## **National Transportation Safety Board**

## **Safety Recommendation**

**Date:** December 20, 2007

**In reply refer to:** A-07-113 through -116

Figure 1. Damaged external power connector receptacles and the surrounding compartment.

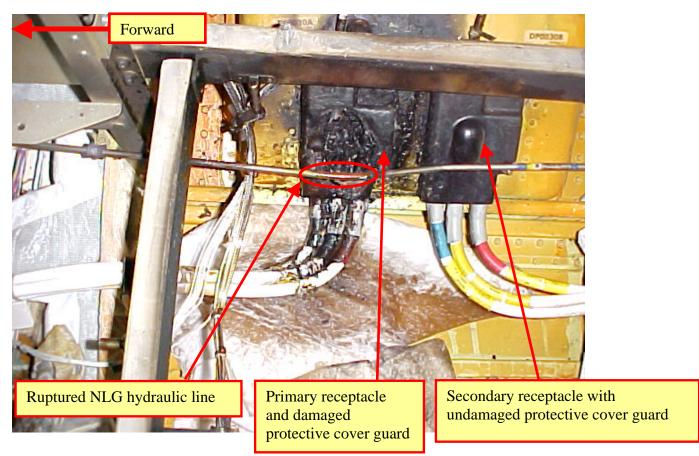
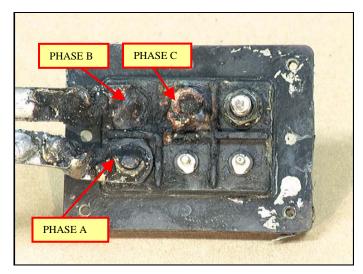
Postincident examination of the airplane revealed that the fire resulted from a combination of electrical arcing between the lower terminal studs at the primary power receptacle<sup>1</sup> and misting hydraulic fluid from a ruptured nose landing gear (NLG) hydraulic line, which is located about 3 inches from the primary and secondary external power receptacles. The primary power receptacle, its protective cover guard, attached wiring, adjacent wire bundles, and the NLG hydraulic line all sustained extensive thermal damage (see figure 1).

Examination of the primary power receptacle terminal block from the airplane involved in the November 15, 2004, event identified evidence of electrical arc damage between three of the phase studs (A, B, and C in figure 2) installed on the back of the terminal block, as well as melted inner surfaces due to the arcing. Additionally, the terminal lug that connects to the phase C stud showed evidence of oxidation and electrical arc erosion. Several of the contact pins exhibited overheating damage, extensive pitting, and considerable corrosion. Metallurgical analysis of the ruptured NLG hydraulic line revealed that it failed due to exposure to molten copper plasma. Examination of the protective cover guard revealed that a portion of its surface had melted as a result of exposure to plasma.

Examination and analysis by the Safety Board of the three submitted receptacles and protective cover guards revealed that electrical arcing within the power receptacles results in copper material eroding from the receptacle's terminal studs and splattering on the back of the protective cover guard, melting the material and creating a hole in the cover. In this condition, the molten copper plasma is free to splatter into the airplane's electrical/electronic compartment, introducing the potential for damage to critical aircraft components located in this compartment, such as a hydraulic line or electrical wiring. Alternately, molten splatter could result in ignition of nearby materials such as dust, lint, or insulation blankets. Such damage could potentially compromise critical aircraft functions. An initial inspection to establish a baseline followed by scheduled inspections would allow maintenance personnel to assess the condition of the primary and secondary external electrical power receptacles and their associated hardware, reducing the potential for arcing or fire.

Require operators of Boeing 777 airplanes to perform regular inspections of the primary and secondary external power receptacles and their protective cover guards to detect signs of worn or overheated pins and thermal damage and repair or replace any damage found. (A-07-113)

Require Boeing to modify and air carriers to install the protective cover guard for primary and secondary external power receptacles for all model 777 airplanes to eliminate the possibility of debris entering the receptacles and causing electrical shorting and arcing between the receptacle studs. (A-07-116)
